## SAFETY WARNING

### SUBJECT: STRIKE Harness

Tear in leg strap side panels

##### STRIKE ind A1

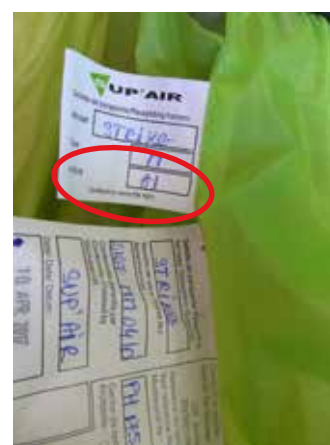
(Production up to April 2017 included)

Open the back storage compartment  
The production index is on the small label

#### Facts/ Ascertainment :

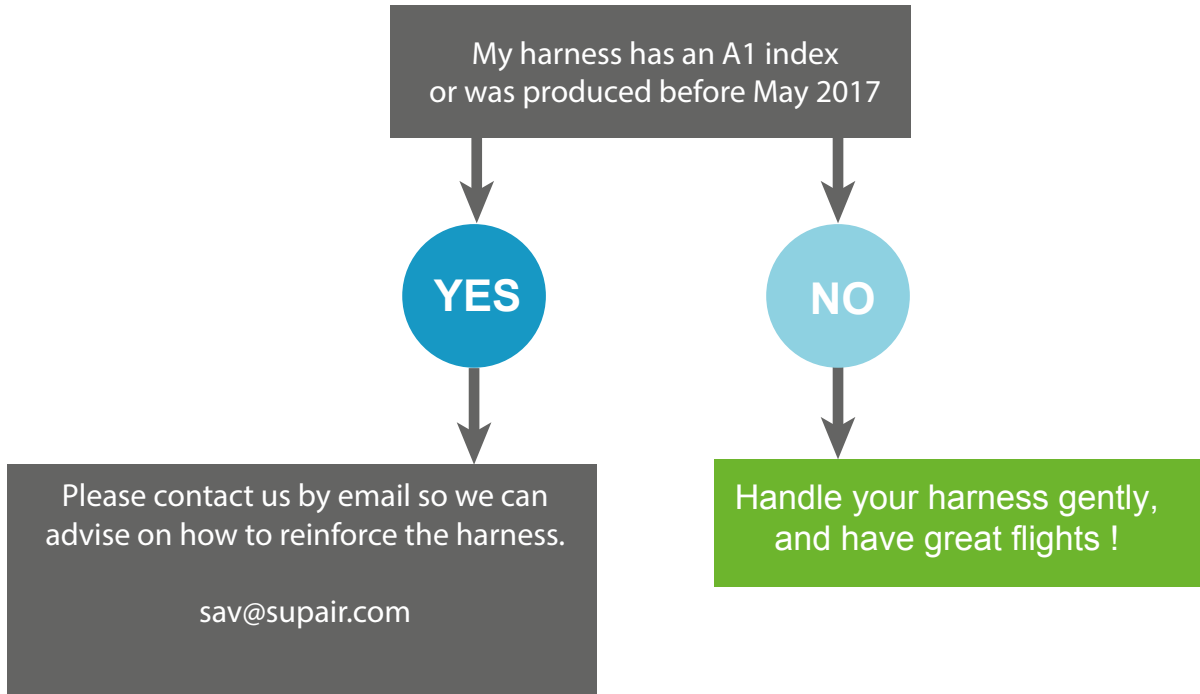
Some tears occurred in the side panel during hard spiral dives or other manoeuvres with high G force. The tears do not compromise the structure of the harness but may destabilise the pilot in the harness during and after the manoeuvre and the harness might become uncomfortable to fly.
